2. DPR-0155 Cochranes– Planning Rebuttal Evidence - Leeston

4. DPR-0436 – P B and J C Nahkies - Dunsandel

DPR Hearing 30.7 Ellesmere Rezoning Requests - Reporting Officer Memo

Figure 1 of Mr Throssell's Rebuttal Evidence

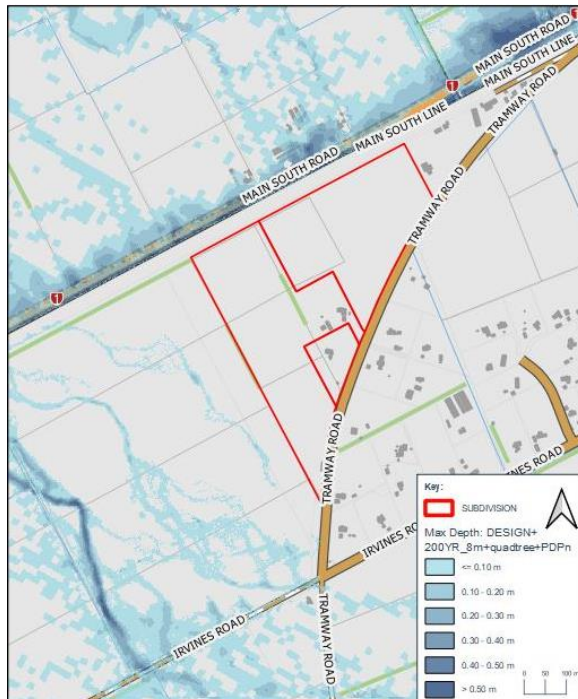
4.5 This new evidence has not been peer reviewed. I am not qualified to comment on the technical aspects of this work. However, in relation to the flooding evidence I note that the map at Figure 1 of Mr Throssell's rebuttal evidence is used to identify the flooding areas for a 200-year event. However, this does not seem to reflect the flooding map outlined in the Proposed District Plan, which I understand to represent a 200-year flood event. These are provided side by side below for comparison. I may have misunderstood Mr Throssell's evidence, but this is something for the Commissioners to consider.
